Changes made as a result of the Application Review and Plan Check

902 Foul Bay Road

Revised Rezoning III July 29, 2021

Landscape Revision List

A1.0 Site Plan + Project Information

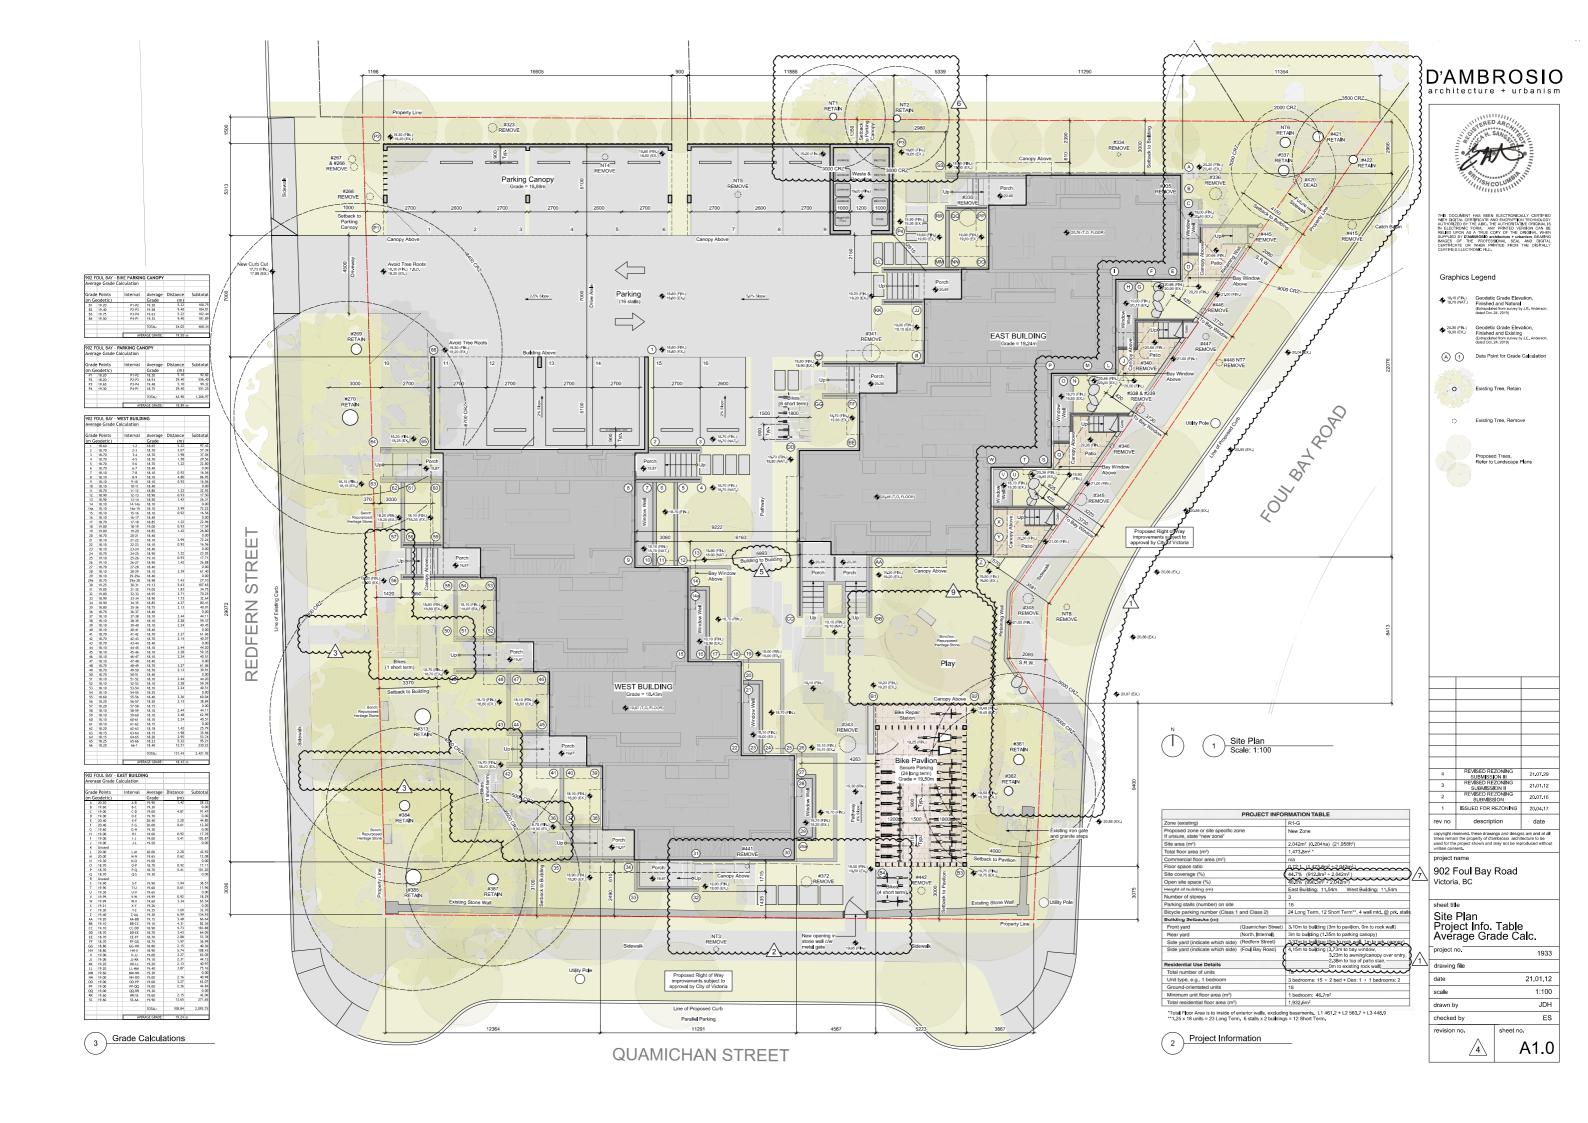
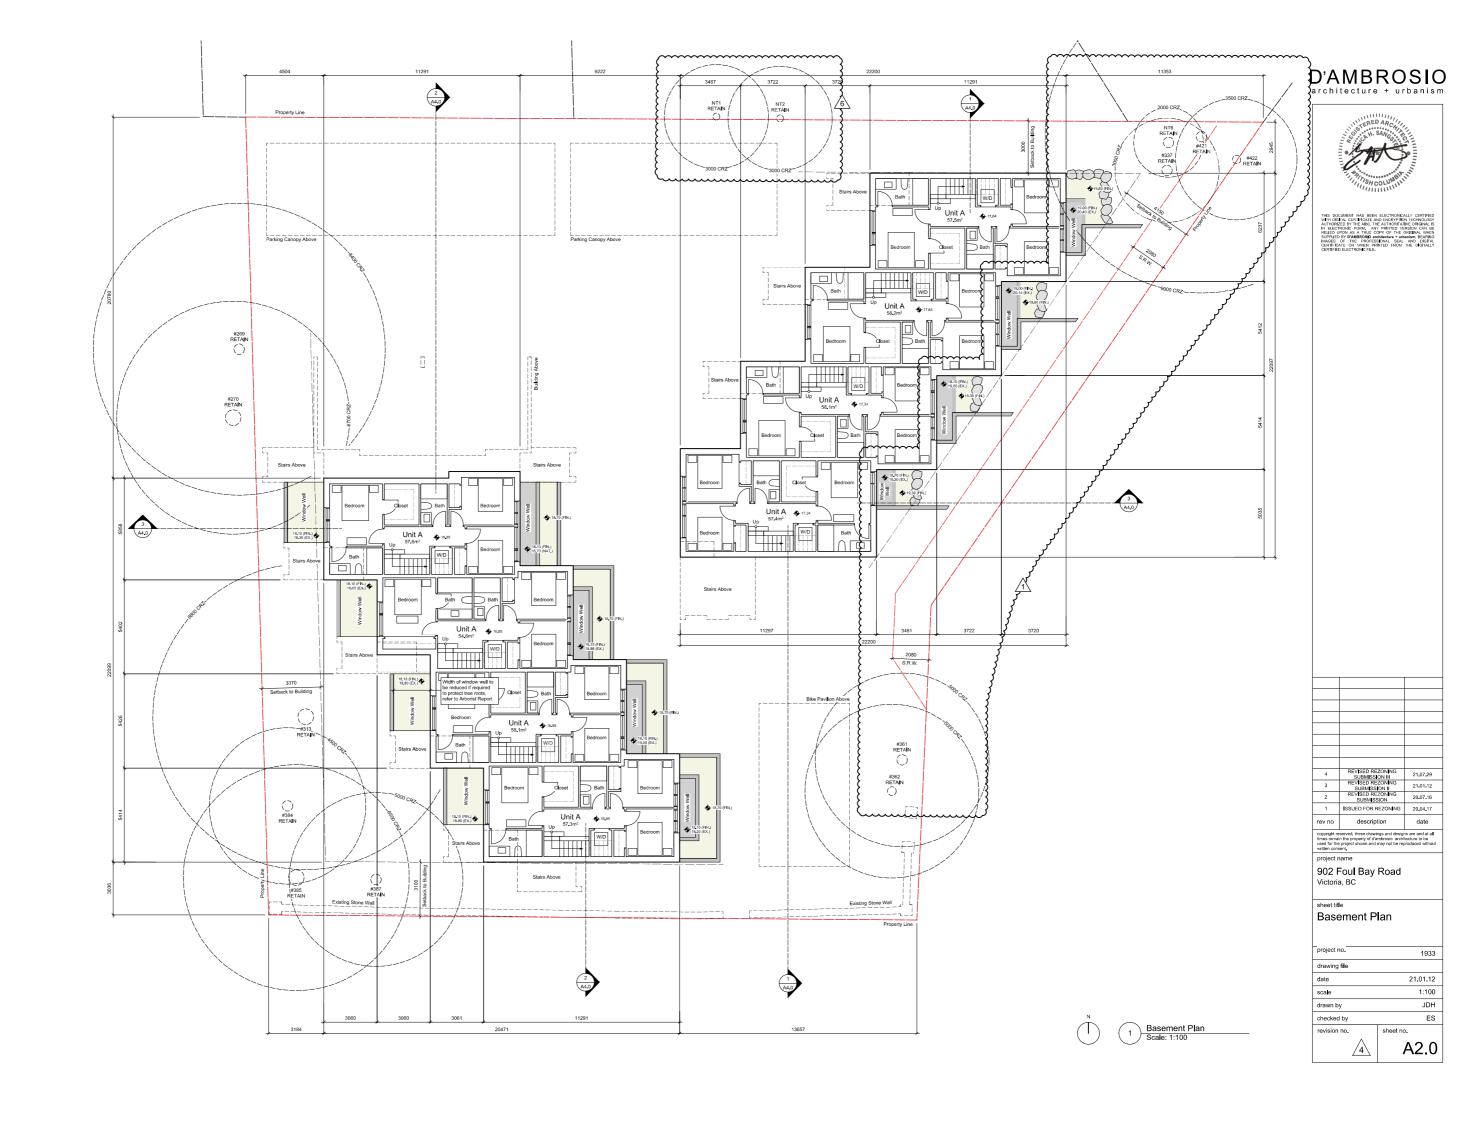
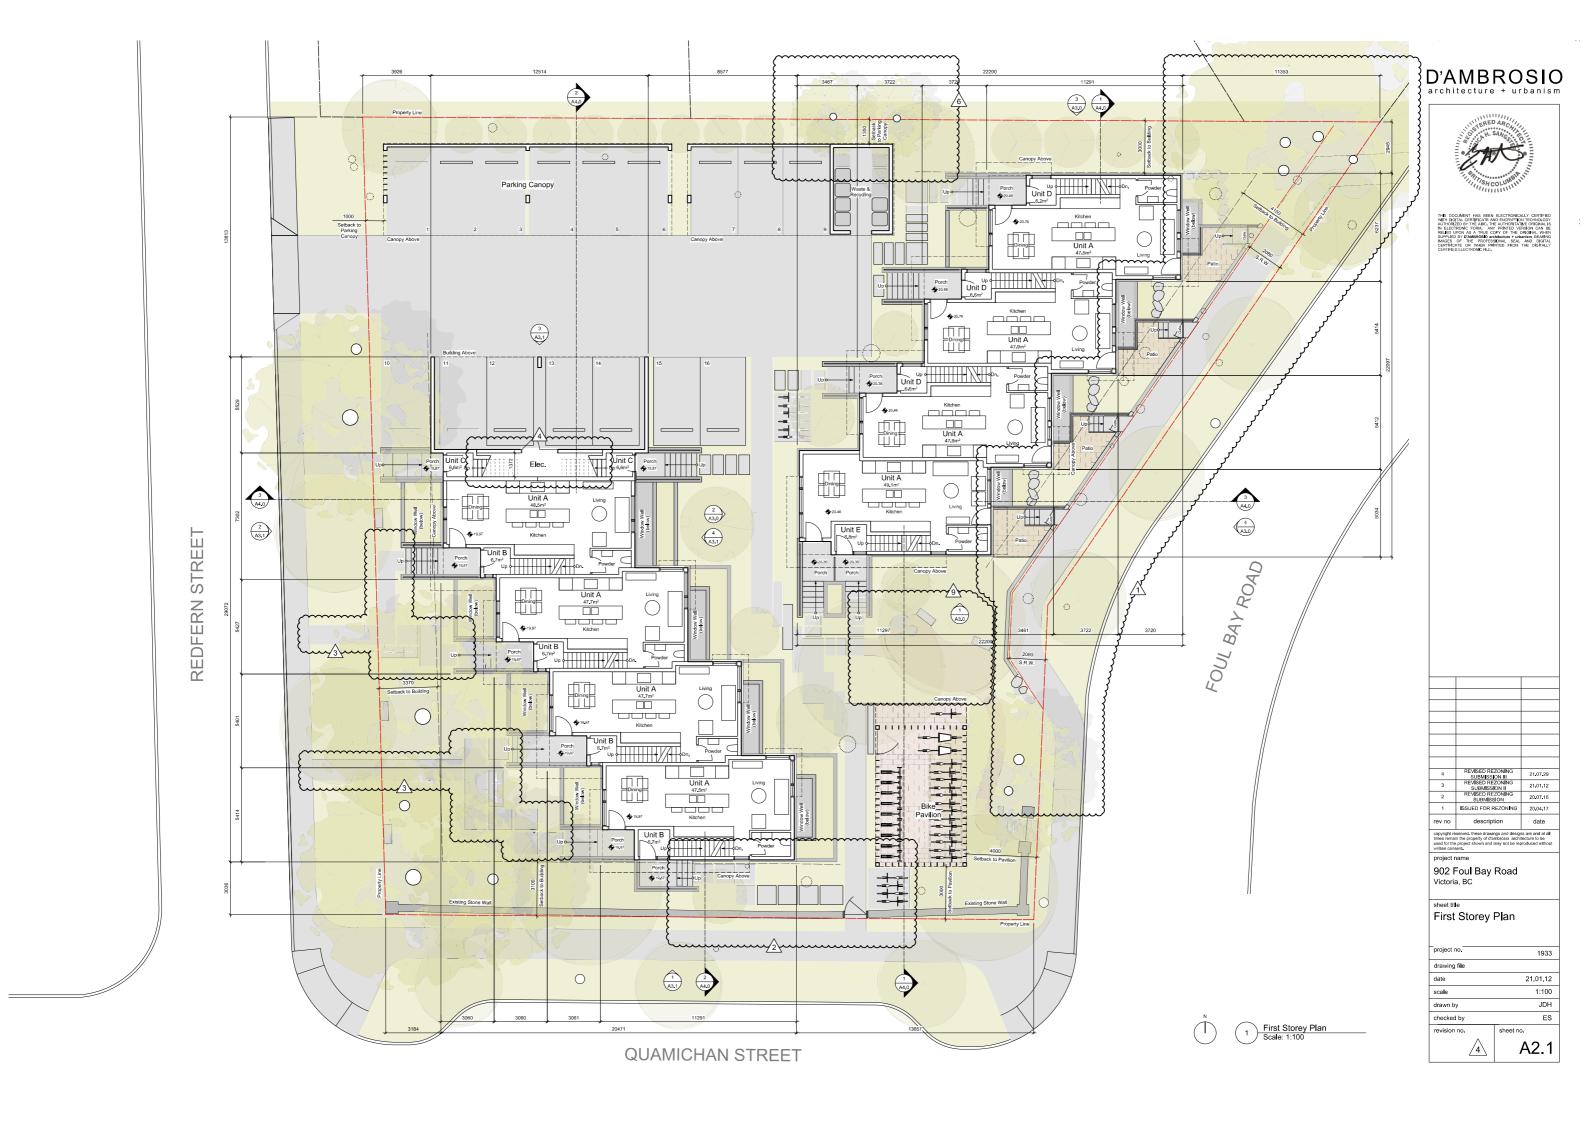
Revision Number	Revision Title	Drawing	Description
1	Foul Bay Frontage	A1.0, A2.0, A2.1, A3.0, A4.0	In response to comments from Development Services, street-facing entries with canopies/awnings and patios with gated steps up the sidewalk have been added to all ground level units on Foul Bay (see item #7 for increase to Site Coverage). In response to comments from the Transportation Planner, a 1.75m paved sidewalk has been added to Foul Bay, stopping at the last unit entry path (future extension is shown dashed). The S.R.W. has also been reduced to exclude the existing heritage rock wall and gate post. Existing trees to be retained and removed have been updated and coordinated with Landscape and the Arborist's report.
2	Quamichan Street Frontage	A1.0, A2.1	In response to comments from the Transportation Planner, the number of openings through the existing stone wall has been reduced to one by combing the unit entry and through-site paths. To accommodate, the short-term bike parking has been moved east, and two spaces have beer relocated adjacent to the Redfern entry paths.

3	Redfern Frontage	A1.0, A2.1	In response to comments from the Transportation Planner, the number of unit entry paths has been reduced by one. Paths outside the property line have been changed to solid paving.
4	Electrical	A2.1, A4.0	An electrical room has been added, under the stairs to Unit C.
5	Distance Between Buildings	A1.0	In response to comments from the Plan Checker, a dimension from the East Building to the We Building (bay window) has been added. Note that the bay window does not overlap the East Building.
6	Tree Clarification	A1.0	Tree location and status updated and coordinated with Landscape and the Arborist's report.
7	Site Coverage	A1.0	Site Coverage has been adjusted to account for the new entry steps and patios along Foul Bay.
8	Redfern Tree	A3.2	Tree size reduced.
9	Play Area	A1.0, A2.1	Configuration of Play Area revised to accommodate new trees.
Leg {	end	Revision bubble Revision numbe

L1 Landscape Site Plan

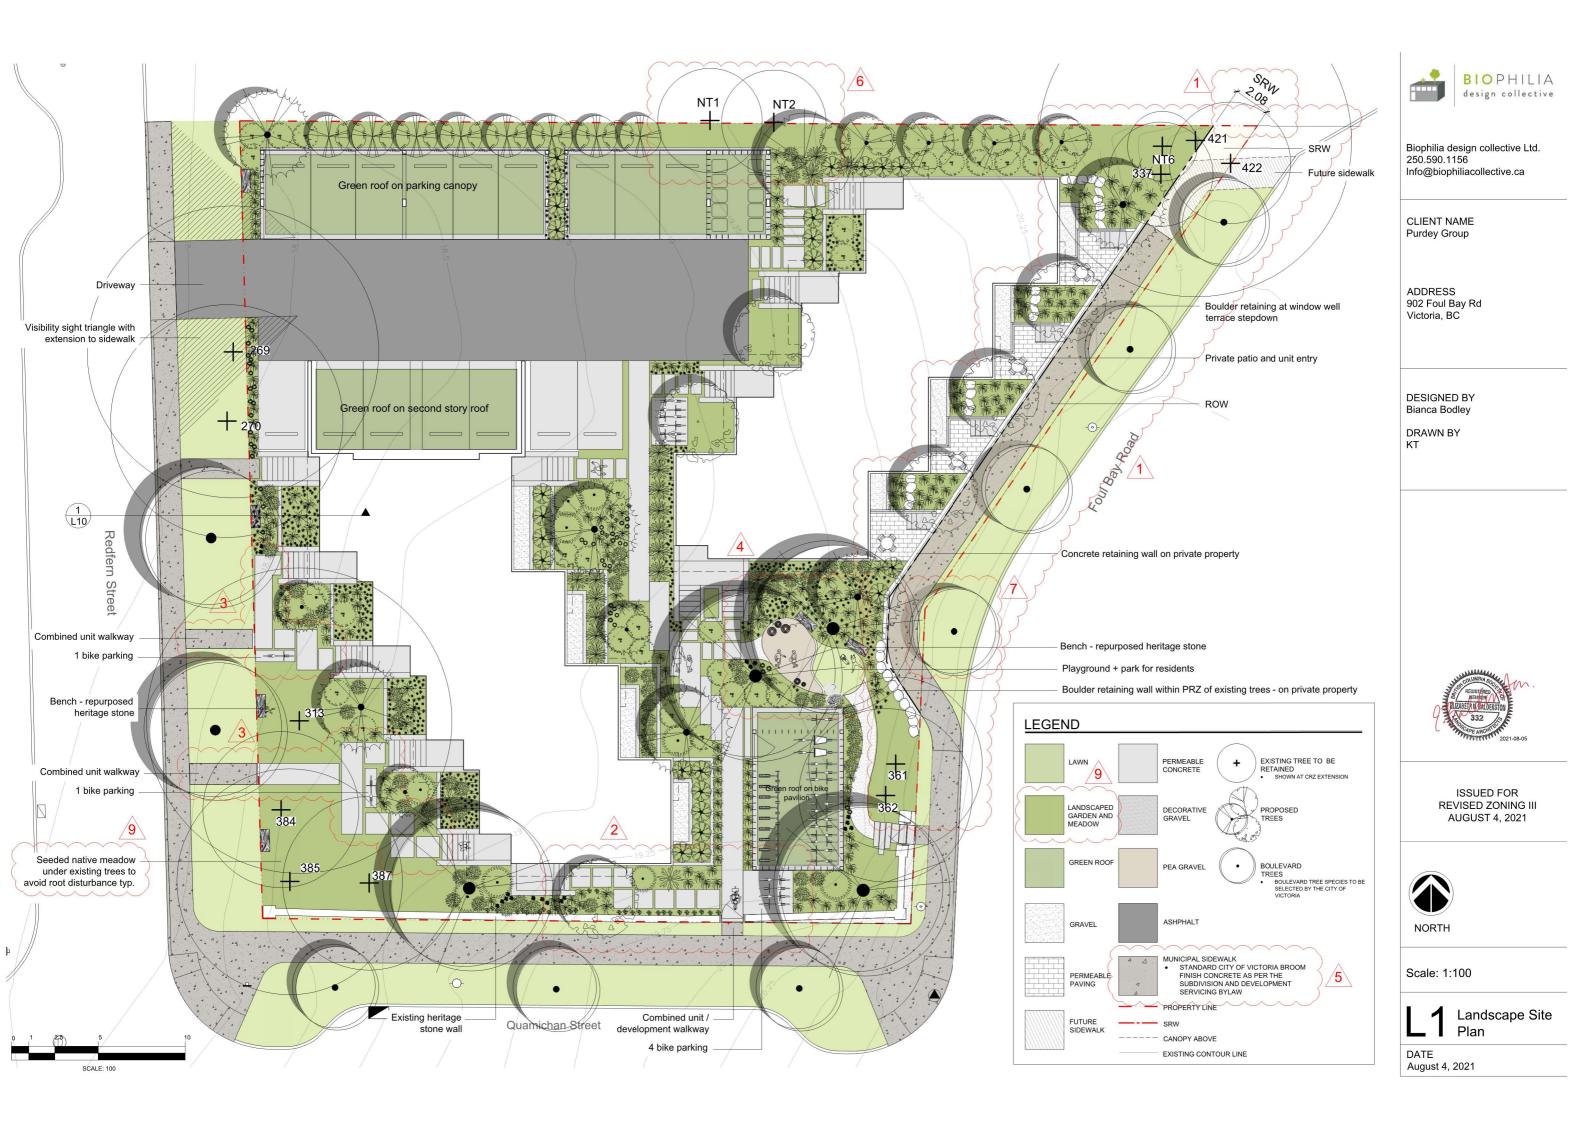
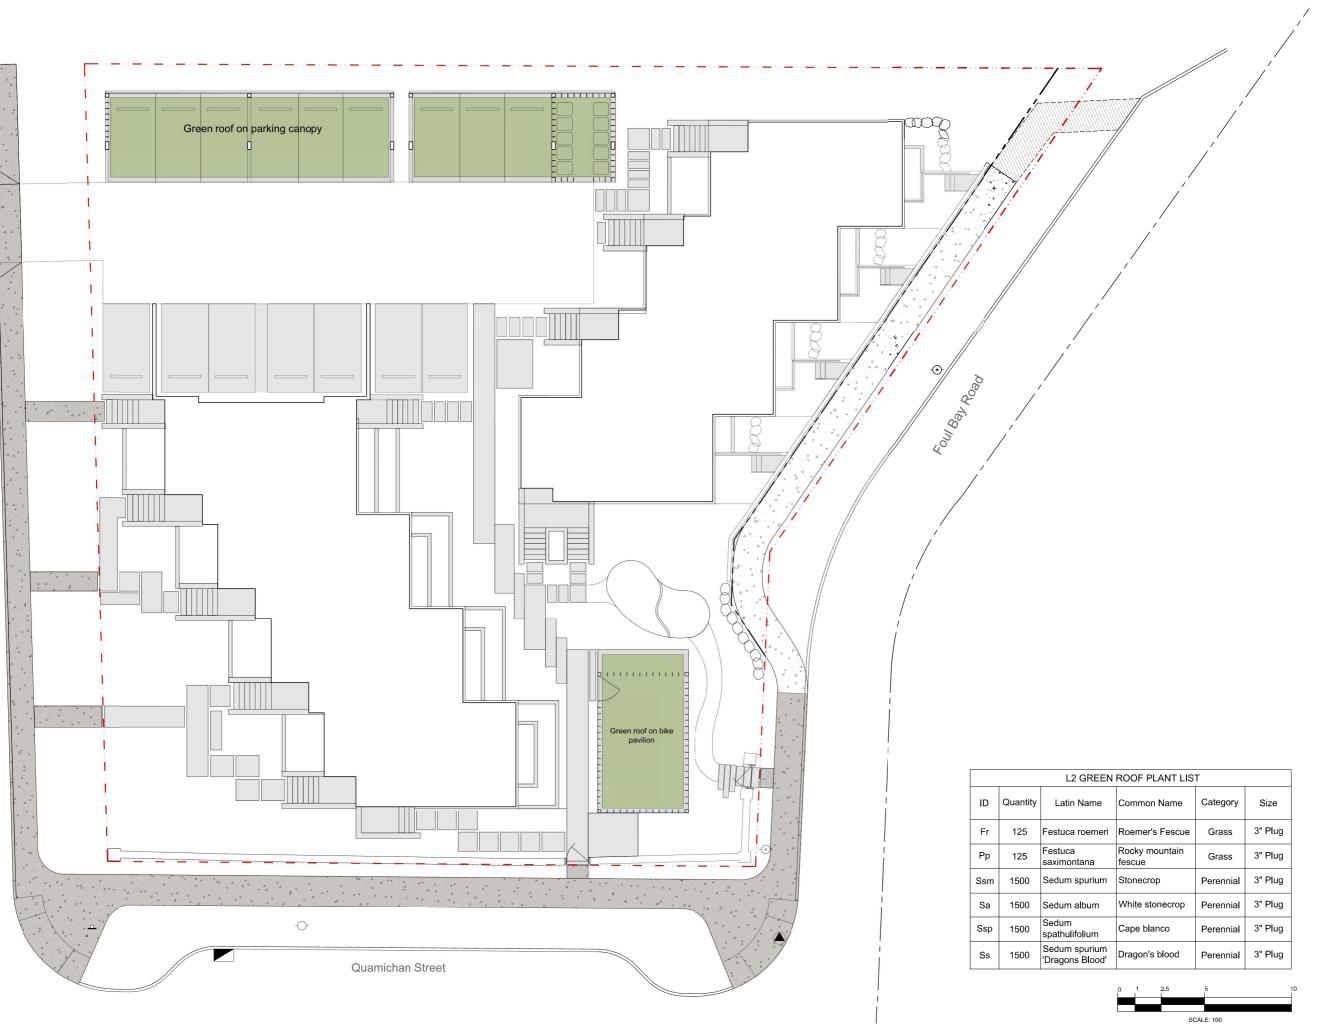
Revision Number	Revision Title	Drawing	Description
1	Foul Bay Frontage	L1	 Street facing entries and patios revised as per architectural Sidewalk revised to 1.75 m width as per architectural / civil Concrete retaining wall moved on to private property as per civil Boulder retaining wall on private property added adjacent to existing trees to reduce impacts to existing trees – in coordination with civil and arborist Municipal sidewalk revised to terminate at northerly unit entry; proposed sidewalk extension dashed – as per architectural / civil Alignment of sidewalk adjusted to provide additional space between the sidewalk and existing trees – in coordination with civil and arborist 2.08 m Statutory Right of Way (SRW) added terminating at end of boulder retaining wall and excluding the heritage wall – as per civil SRW dimensioned and highlighted on landscape plans Updated civil plans incorporated into landscape plans showing all existing and proposed utilities and power poles Civil adjusted location of proposed water service to accommodate an (1) additional boulevard tree

2	Quamichan Street Frontage	L1	Sidewalks (2) crossing municipal frontage combined; entry to unit revised, bike parking shifted to other side of sidewalk and reduced from 6 to 4 bike parking spaces – additional bike parking (2) provided adjacent to units on Redfern Street Walkways to units adjusted toward buildings to provide additional undisturbed area adjacent to existing trees
3	Redfern Frontage	L1	Sidewalks (2) crossing municipal frontage combined Bike parking (2) added at shared entry walkways
4	Park / Playground	L1	Shape of park / playground revised to provide additional offset for proposed trees from bike parking pavilion
5	Municipal Sidewalks	L1	All walkways on municipal property revised to standard broom finish concrete sidewalks
6	Existing Trees	L1, L4	 Existing trees on landscape drawing updated to match legal survey locations Existing trees to remain / remove updated as per arborist Existing trees on adjacent property to remain

7	Tree Planting	L1, L4	Additional street tree added to Foul Bay frontage Tree planting in general revised in response to site plan changes Replacement trees revised as per City comments Summary of trees to be removed and replacement trees required updated
8	Tree Protection Fencing	L4	See arborist report for tree protection fencing specifications, location and phasing instructions
9	Shrub Planting	L1, L8	 Shrub planting in general revised in response to site plan changes Proposed shrubs removed from underneath existing trees to minimize disturbance to tree roots as per City comments Shrubs removed from within 0.45 m from property line as per City comments (assume groundcovers and perennials are acceptable) Shrub designations updated as per City comments Methodology for percentage analysis noted as per City comments
10	Arborist Report	L5	Arborist tree retention and removal spreadsheet updated
11	Soil Volume	L7	Drawing indicating available soil volume per tree added
